CASTLEGAR & DISTRICT COMMUNITY COMPLEX ROOF REPLACEMENT PRJ #24055

ADDENDUM NO. 2

Issued: May 20, 2025

1 ROOF PLAN
SCALE: 1/8" = 1'-0"

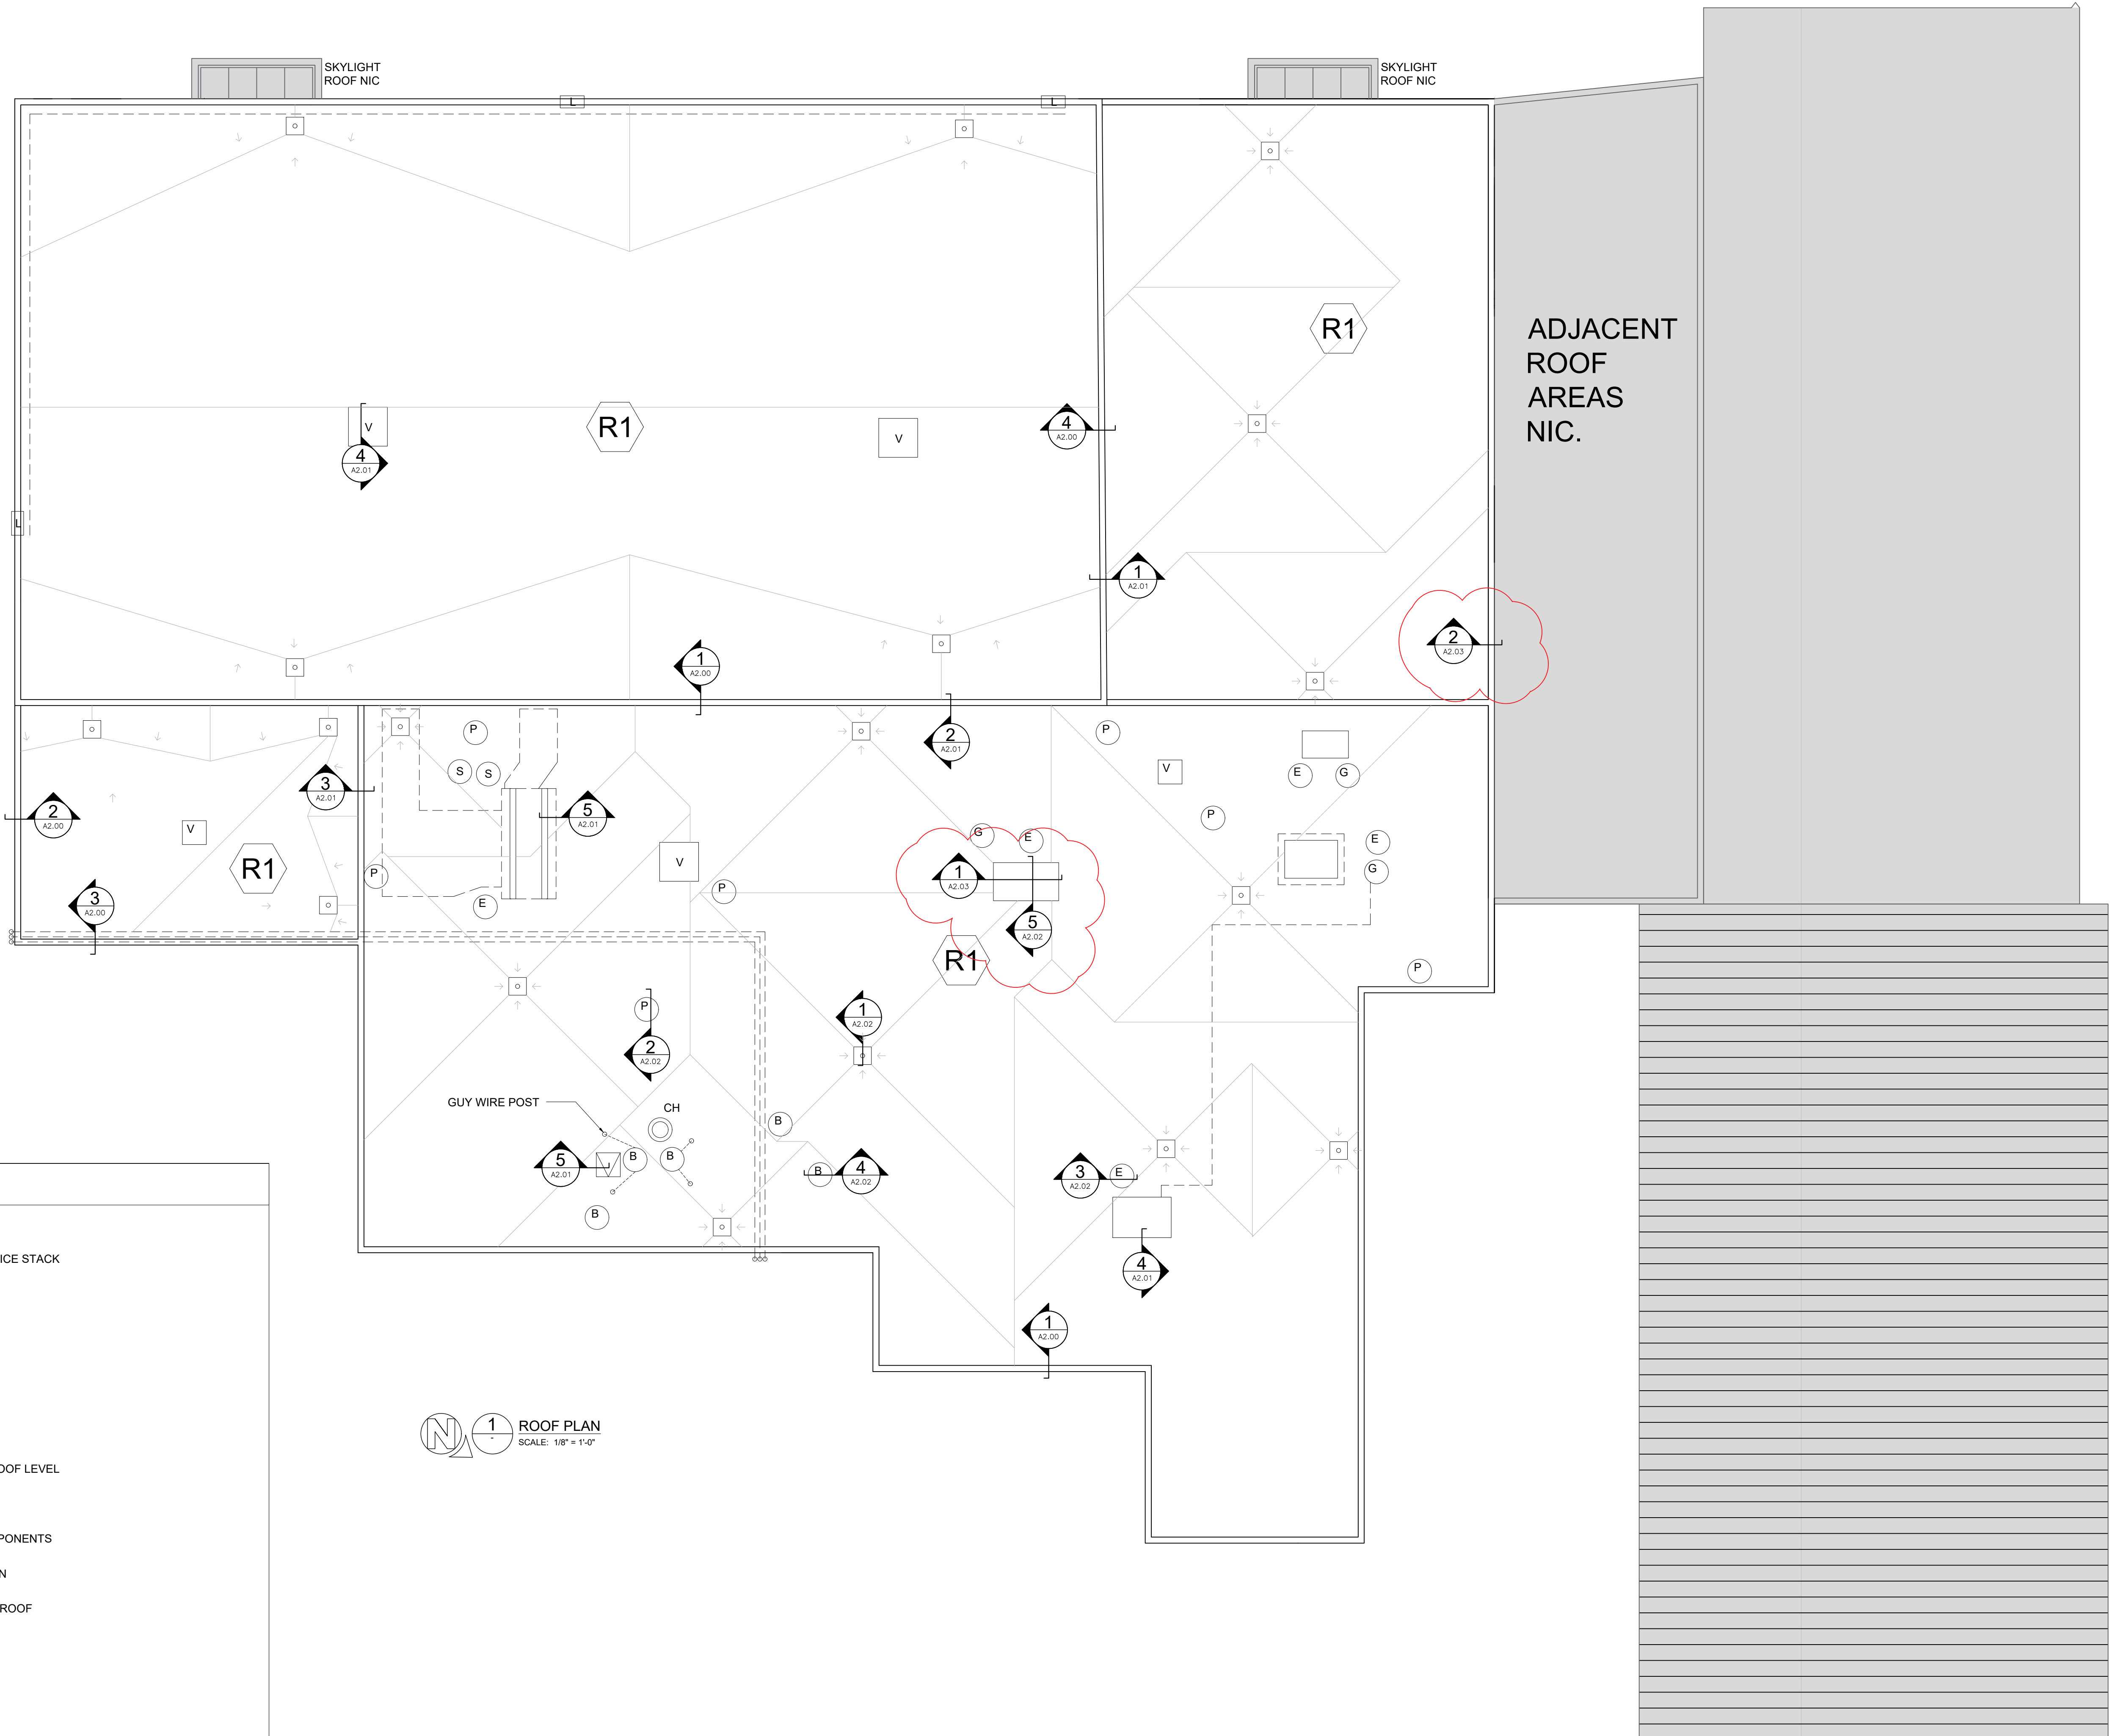
- .1 As noted on A1.01, contractor to retain qualified electrical and mechanical trades to assist with disconnection and reconnection of any mechanical / electrical equipment, lines or duct to allow the removal of the existing and installation of the new roof assembly.
- .2 As shown in A1.02 Roof Plan, the upper roof (ER4) has two main slopes extending from center ridge to the east and west parapets with crickets to direct water to the drains. The lower south roof (ER3) has a two-sided slope with crickets to direct water to the drains. The two other lower roofs (ER1 & ER2) are four-sided slope packages.

- .1 Refer to attached revised **Drawing A1.02**, showing callouts for the new drawings listed below.
- .2 Refer to attached revised **Drawing A2.02**.
 - .1 **Detail 1**, Typical drain detail requires only a 2" thickness below the drain and slope package can start at edge of the sump.

4 TYPICAL CHIMNEY DETAIL
SCALE: 3"=1'-0"

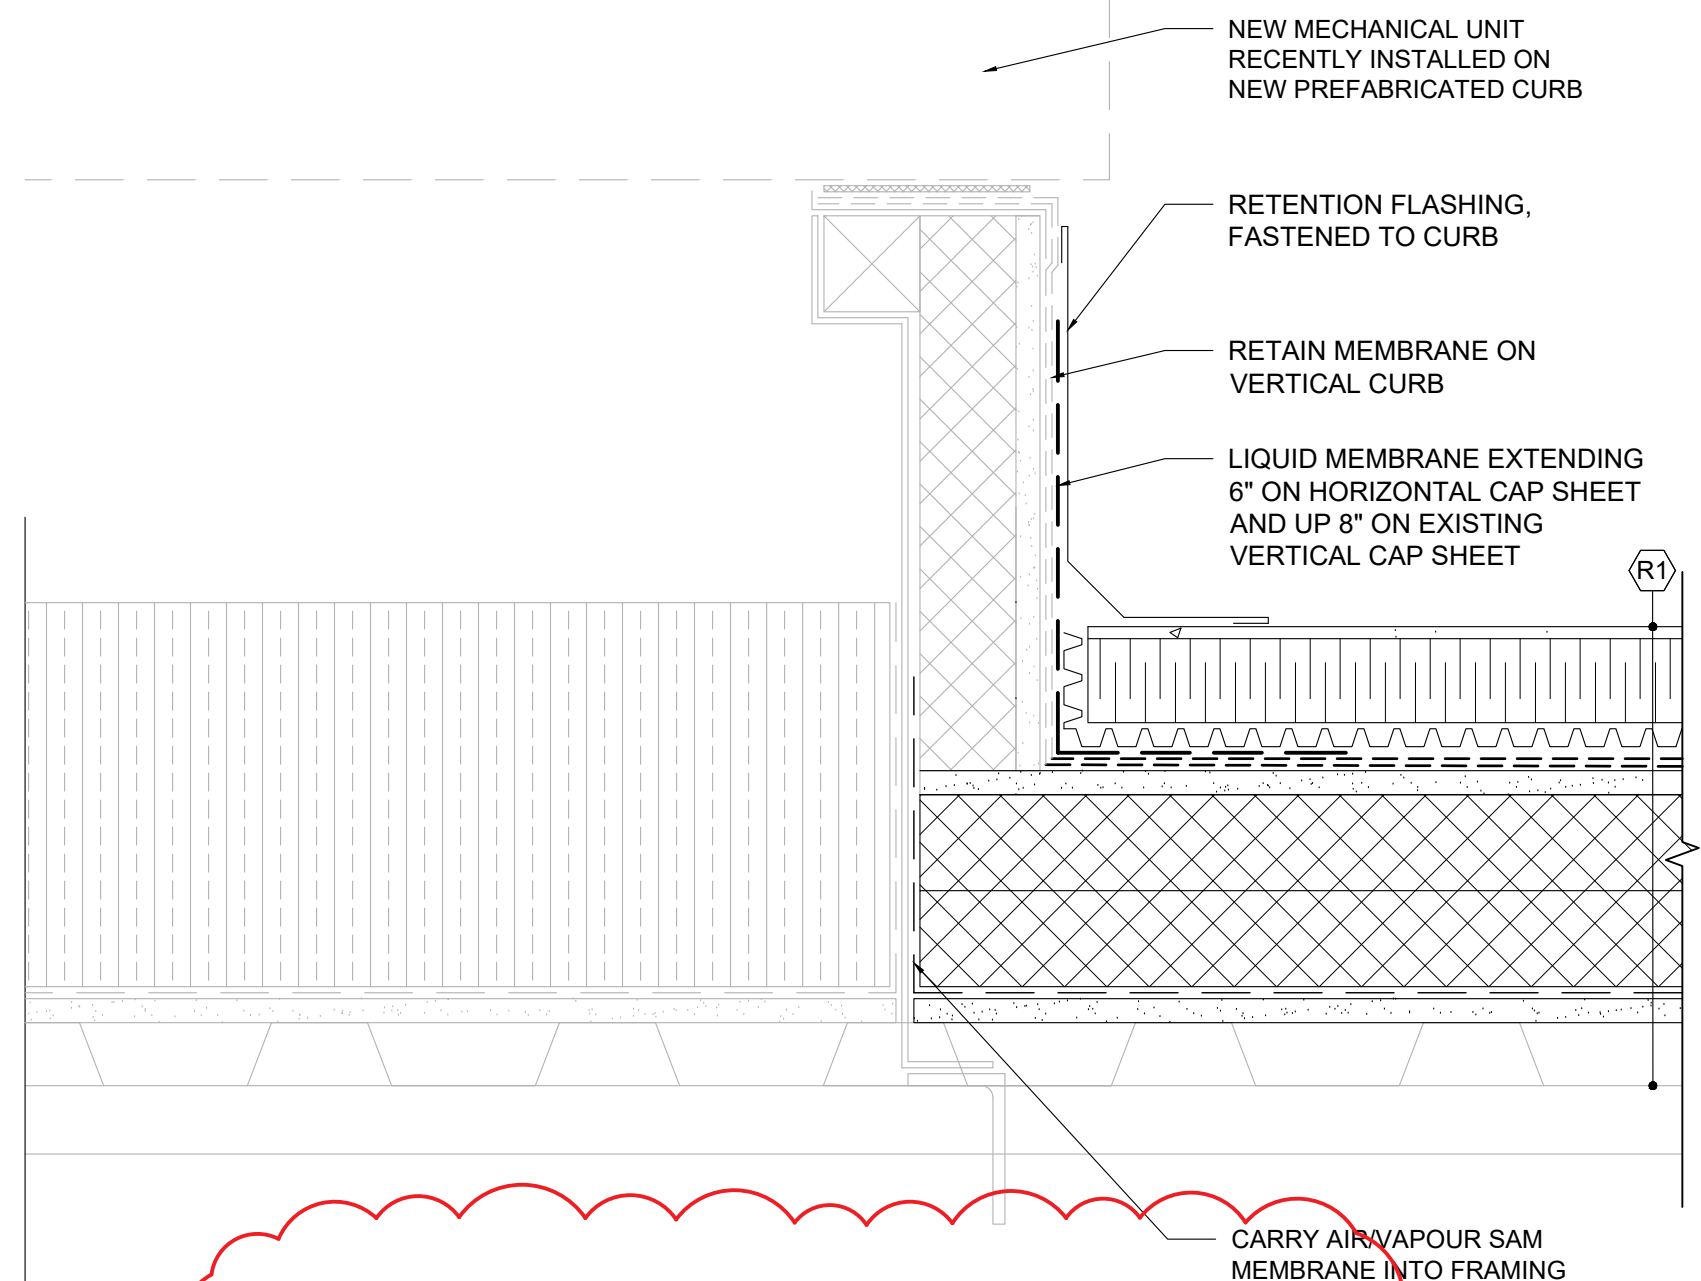
- .2 **Detail 4** has been revised to show sealant joint to chimney, no membrane lap.
 - .3 **Detail 5** has been renamed as **New Roof to Mechanical Curb (Recent)**. This detail assumes that the new mechanical unit and curb has been installed and waterproofed to the existing roof. The new roofing will transition onto the recently installed curb and waterproofing.

A2.03

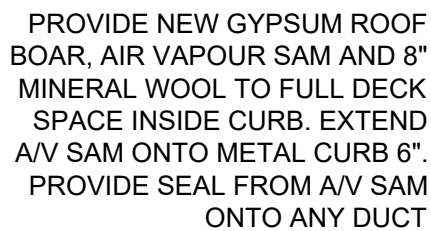
- .3 Should the mechanical unit referred to in **Detail 5** above not be installed before this project roofing starts, attached is a new **Detail 1, Drawing A2.03, Mechanical Unit Detailing**. Roofing Contractor will coordinate with the mechanical contractor to install inside the curb air / vapour layer and insulation and install new roofing to the new curb as shown. Provide the change in price and time in Alternative Price No. 1.

- .4 Refer to attached **Drawing A2.03** with new **Detail 2** for the divider curb between lower north roofs (ER1 & ER2) and the existing north roof are to remain.
